Our Ref: 029/2026/02-DJB - Please quote in all correspondence.

**Re: Lower Road, Breachwood Green – Access Location.**

Figure 4 – Distance to Junctions

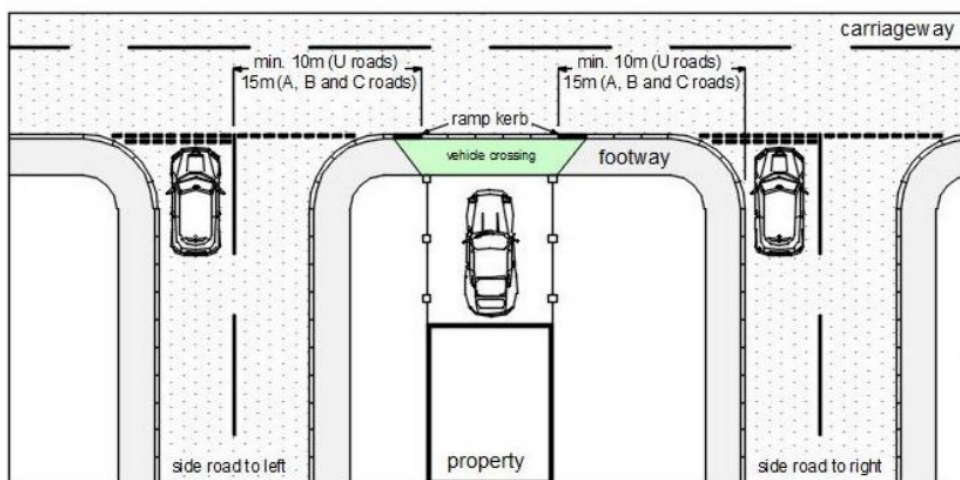
To illustrate our understanding, we have referenced Figure 4 from the Suffolk C.C policy, as similar diagrams are not included within the Hertfordshire C.C guidance, as we believe the expectations of these two Highway Authorities are similar. This diagram shows that the concern is with regard to

accesses/ junctions on the same side of the road as each other, with no reference to accesses on opposite sides of the road.
